INDEX OF SHEETS

PROPOSED IMPROVEMENT INTERSECTION PROJECT TOWN OF HARTLAND COUNTY OF WINDSOR THREE CORNERS INTERSECTION

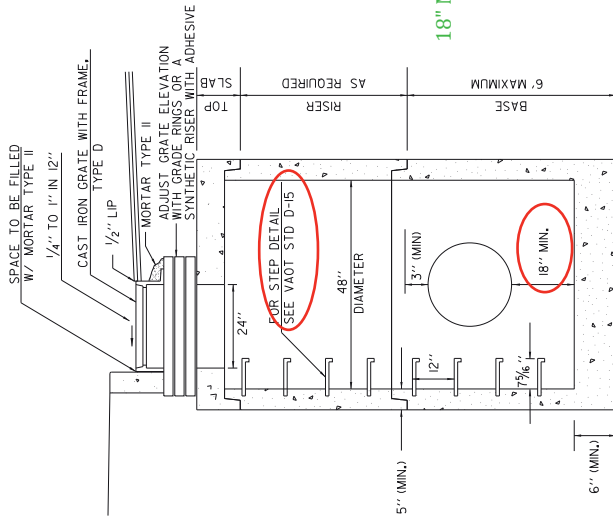
VHB RESPONSE: DETAIL UPDATED

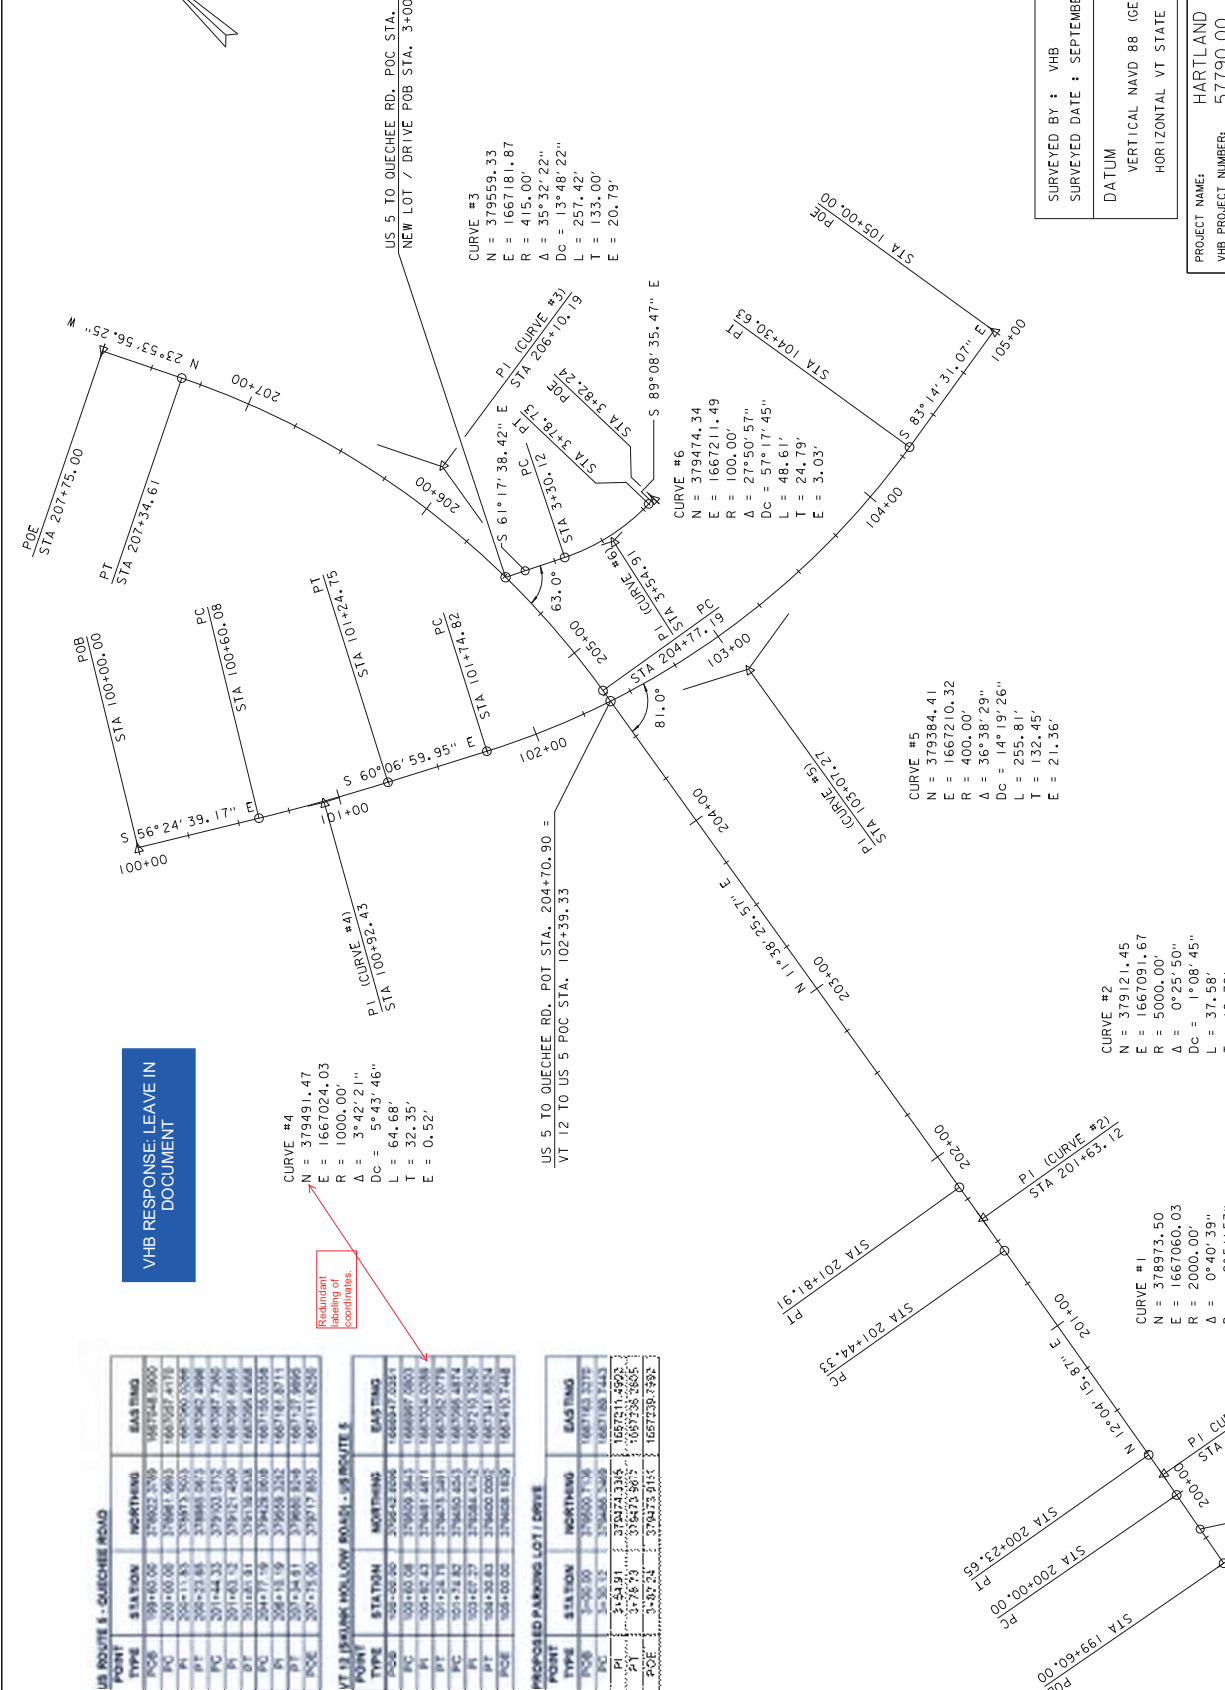
VHB RESPONSE: LEAVE IN DOCUMENT

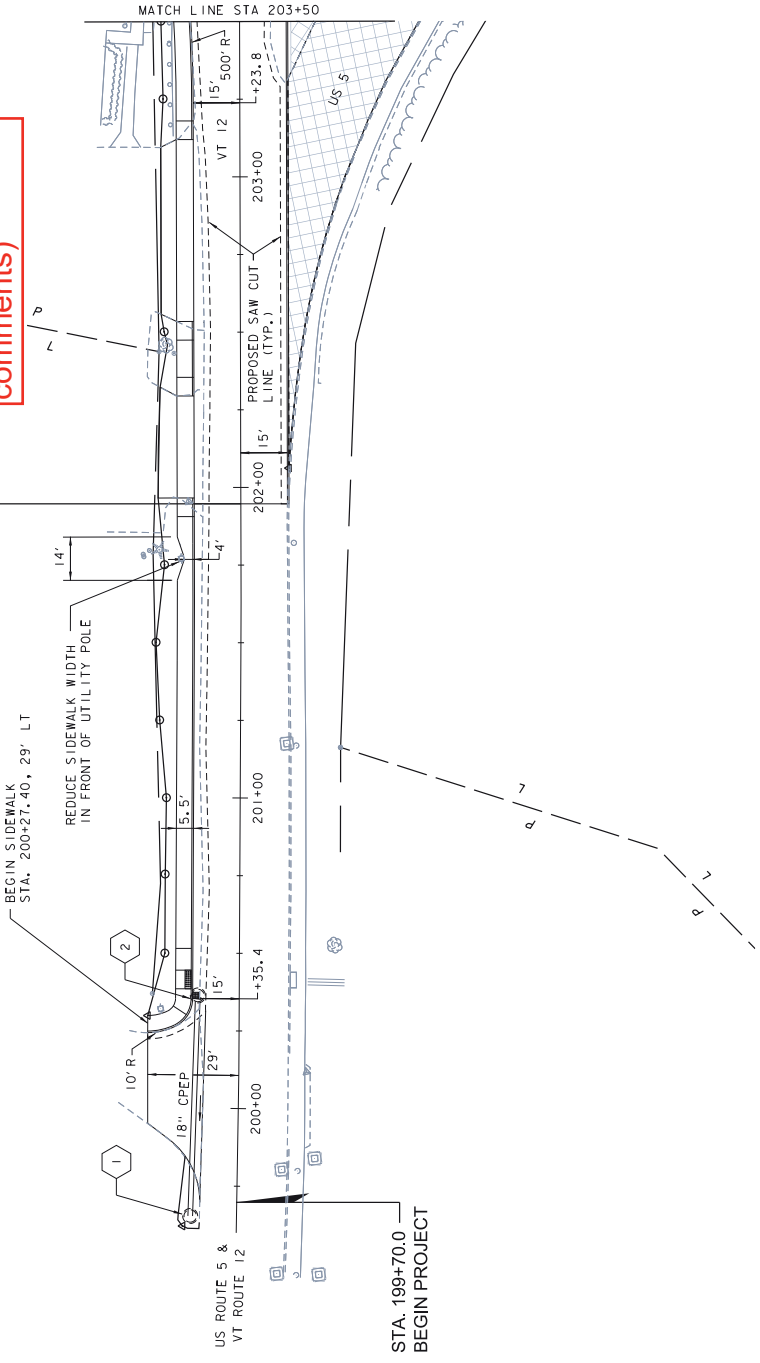
VHB RESPONSE: WE MADE REVISIONS TO THESE TWO DRIVES. UNDERSTANDING THAT THEY MOST LIKELY WON'T GET CONSTRUCTED UNDER THIS CONTRACT.

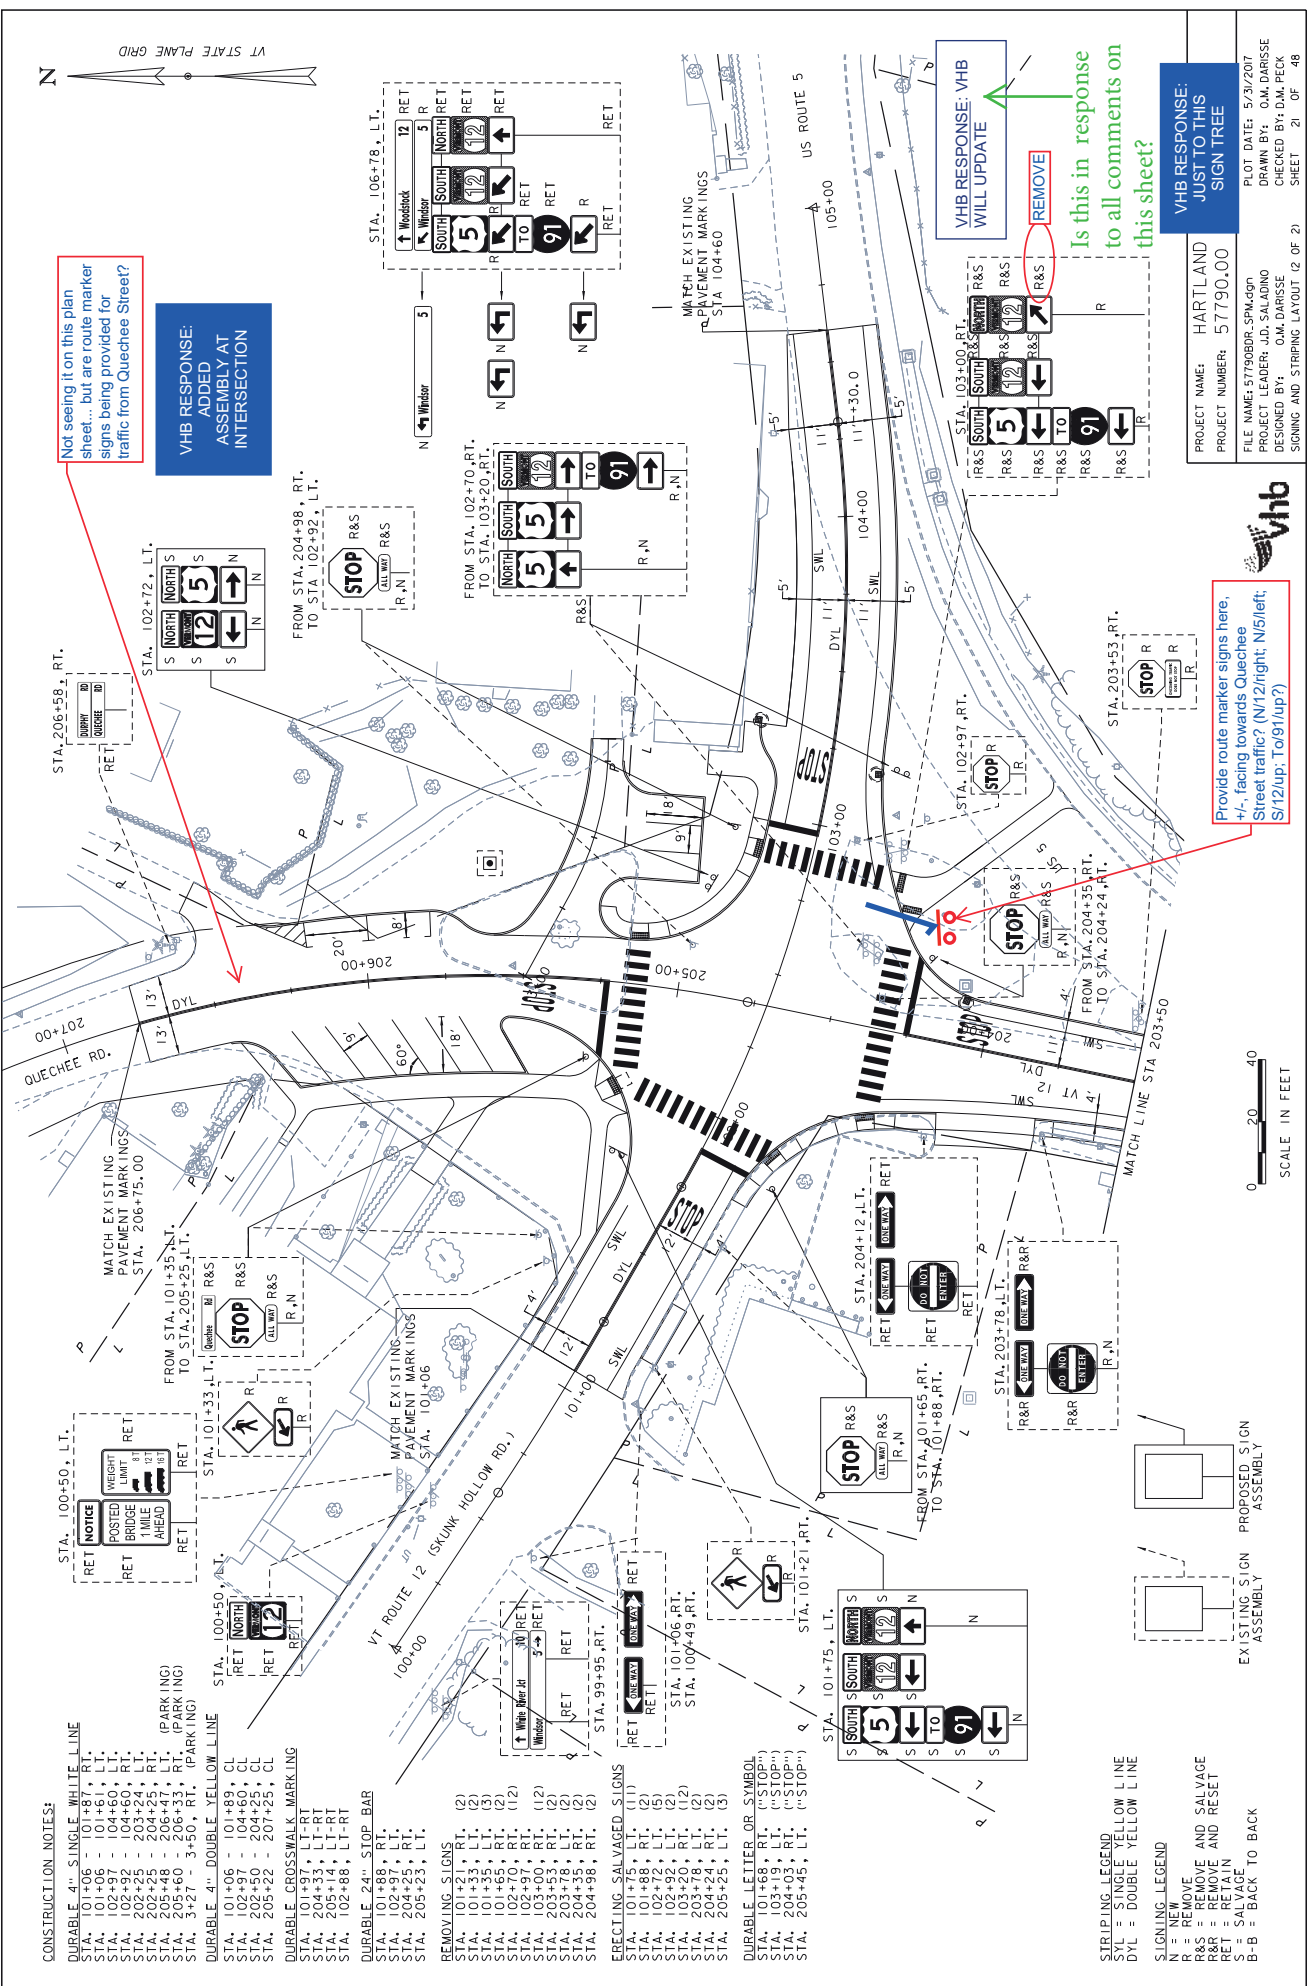
VHB RESPONSE: JUST TO THIS SIGN TREE

VHB RESPONSE: VHB WILL UPDATE

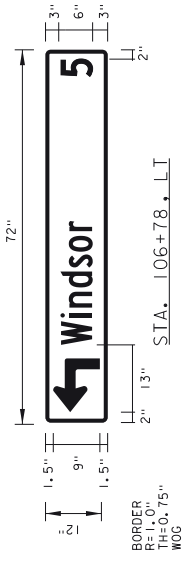
VHB RESPONSE: VHB WILL UPDATE

VHB RESPONSE: VHB WILL UPDATE

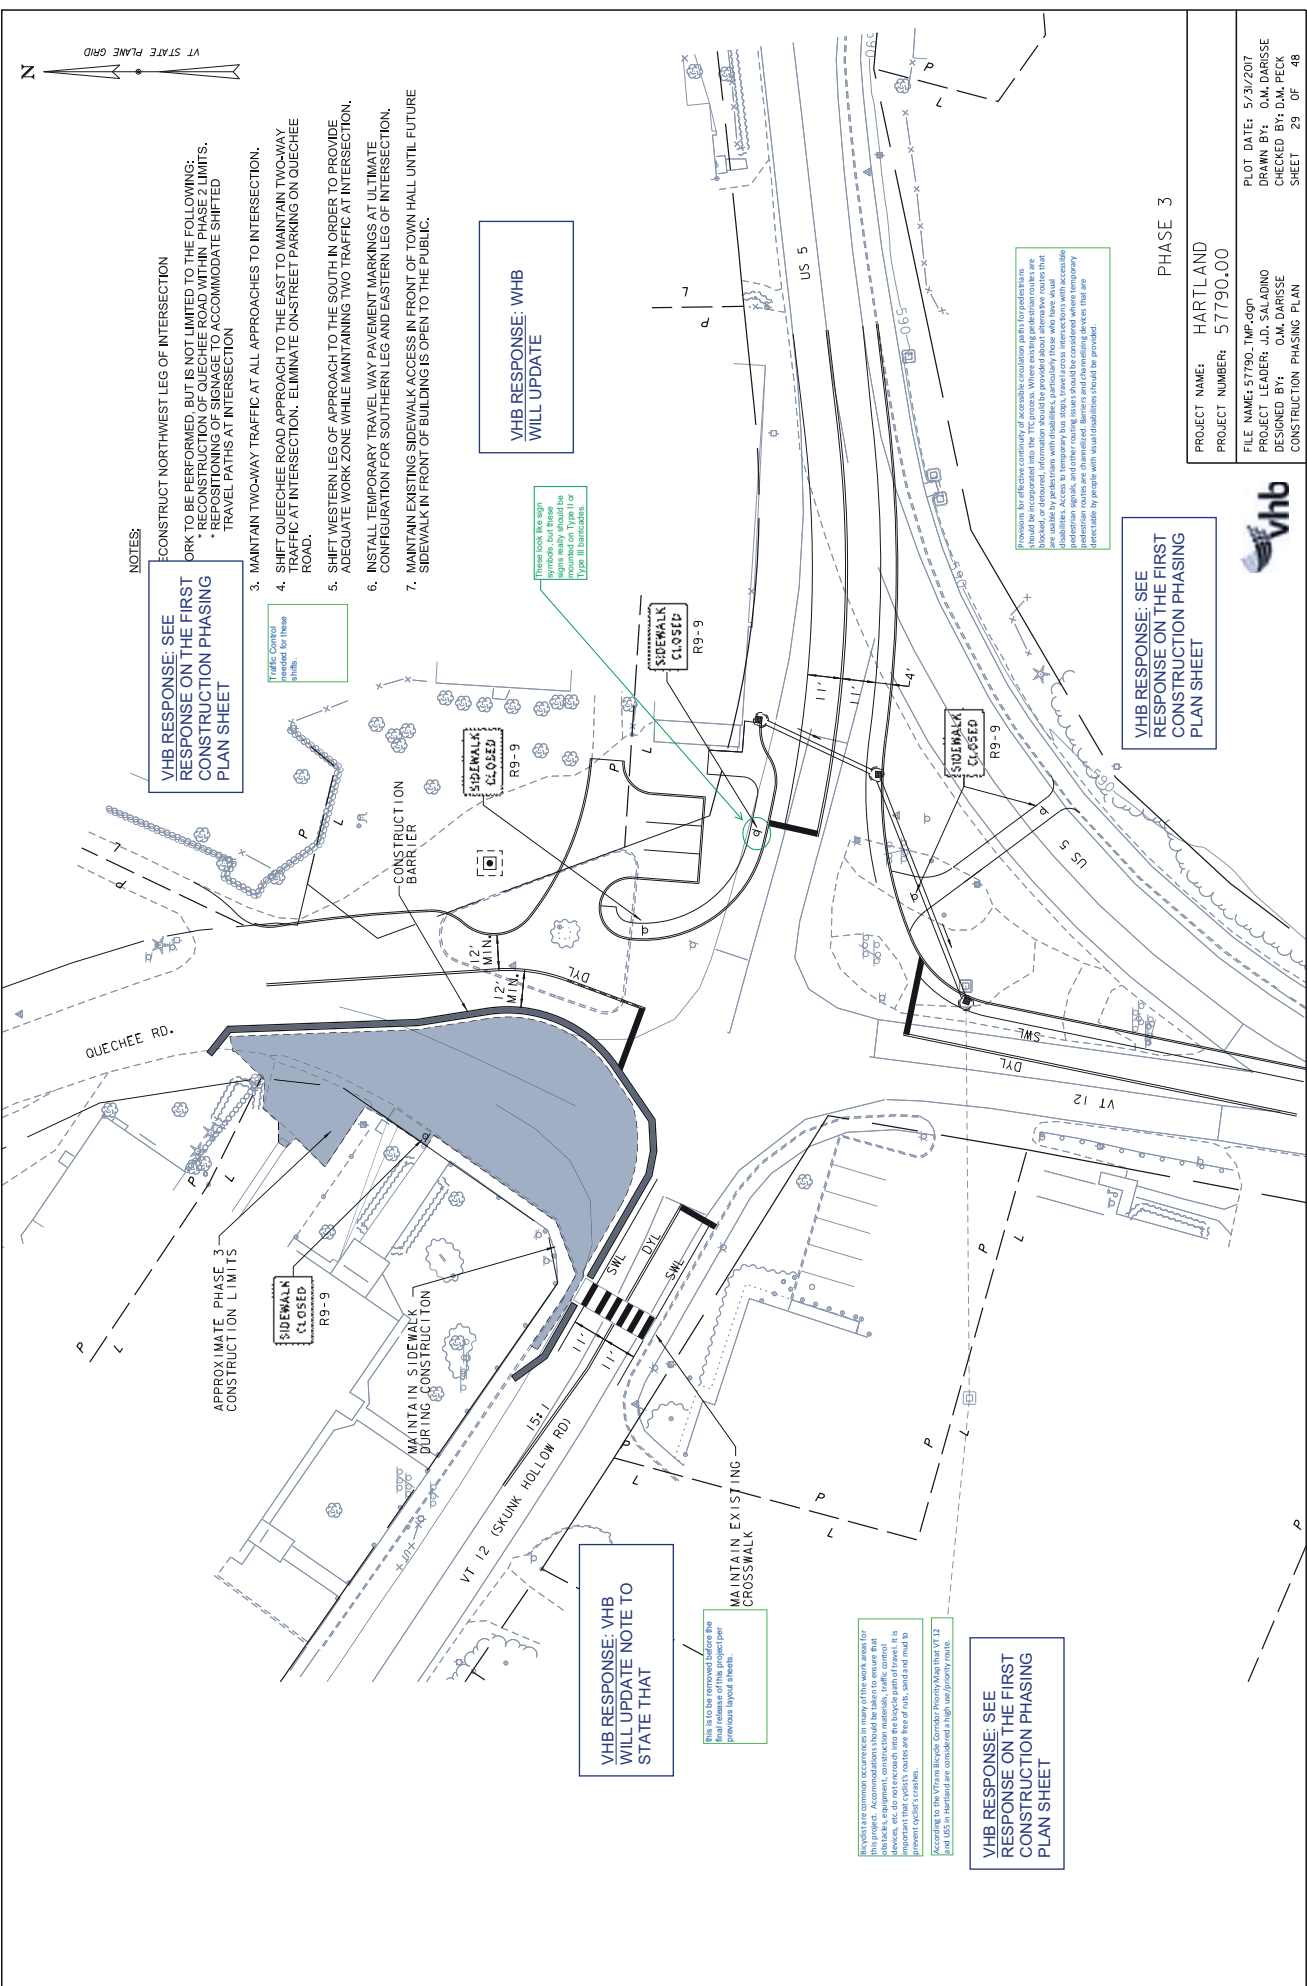
VHB RESPONSE: SEE RESPONSE ON THE FIRST CONSTRUCTION PHASING PLAN SHEET

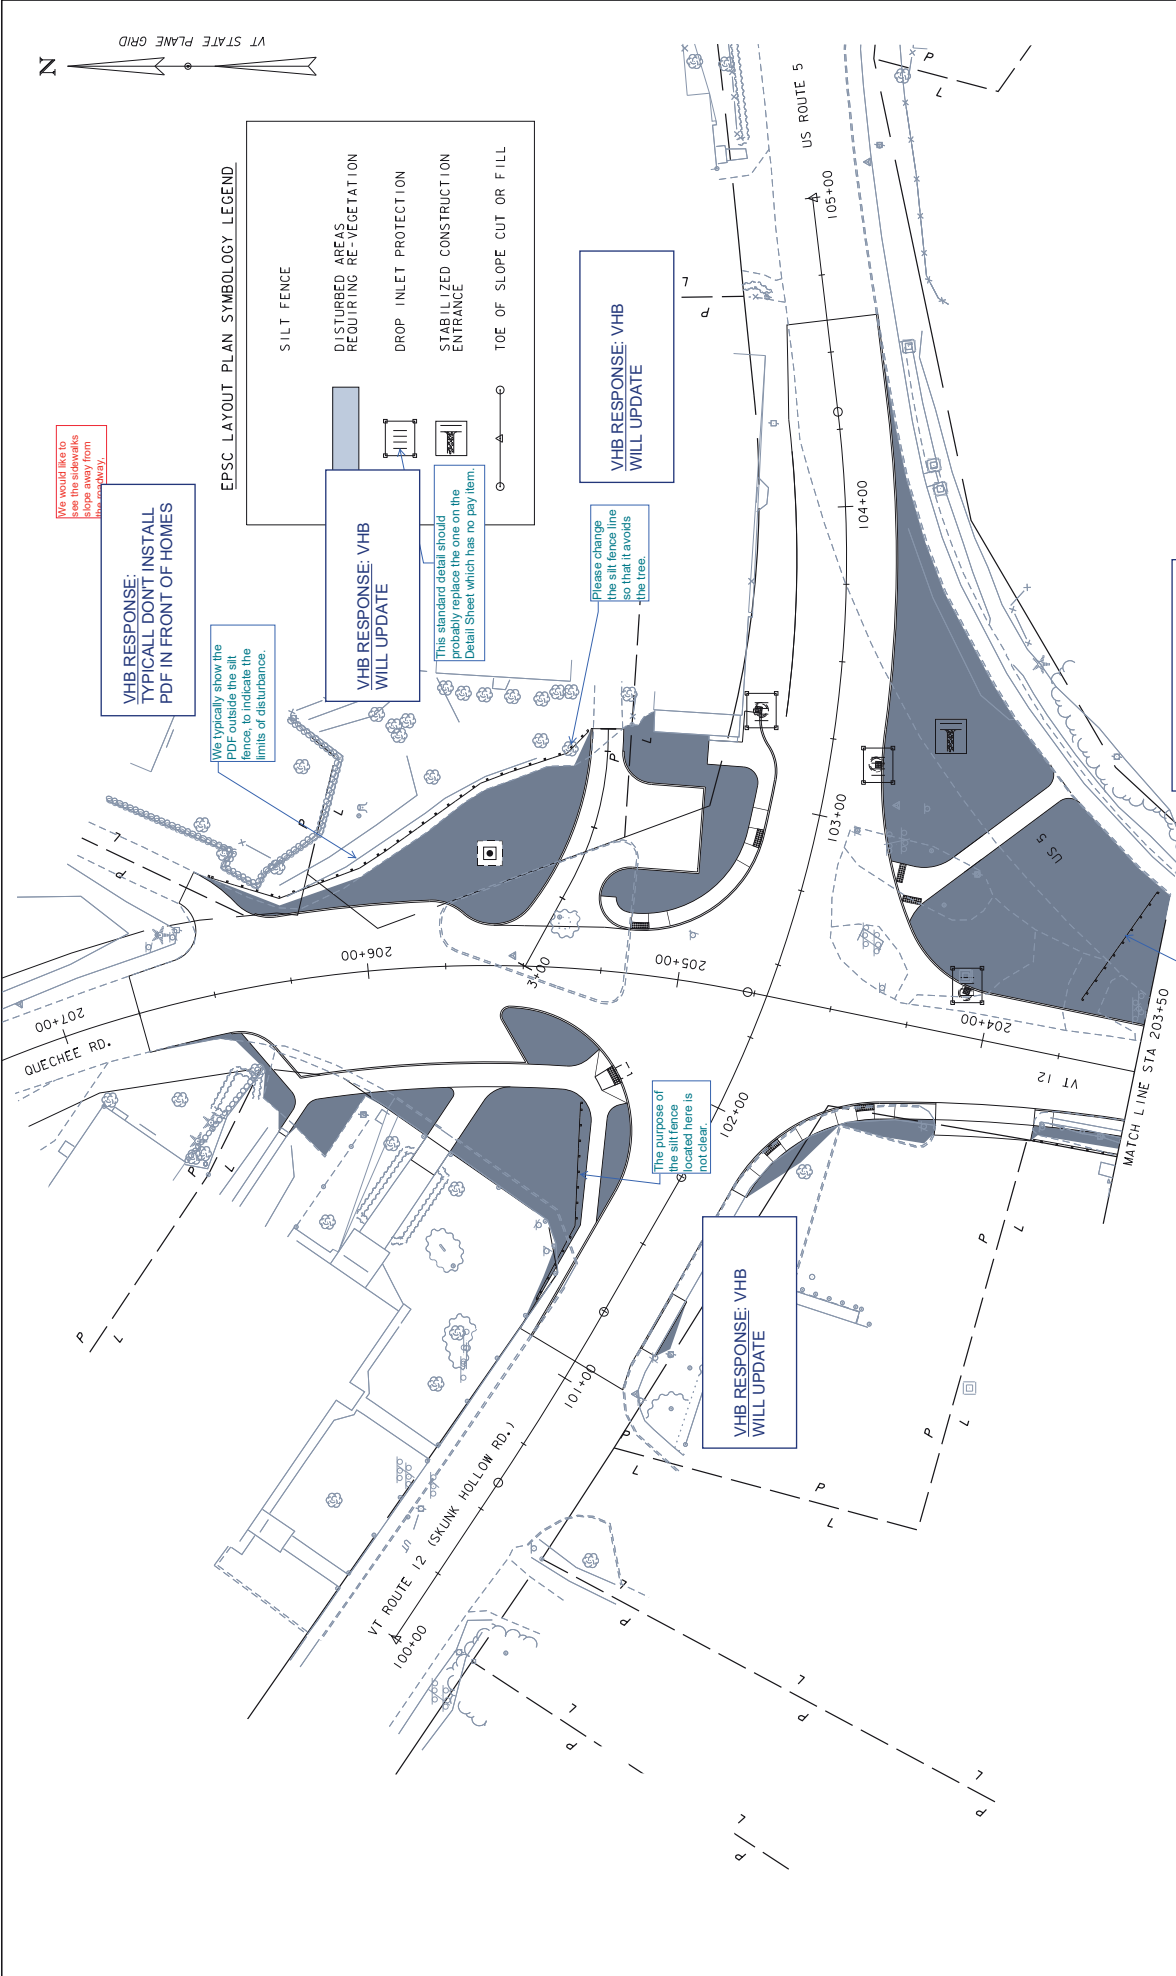
VHB RESPONSE: VHB TYPICALLY DON'T INSTALL PDF IN FRONT OF HOMES
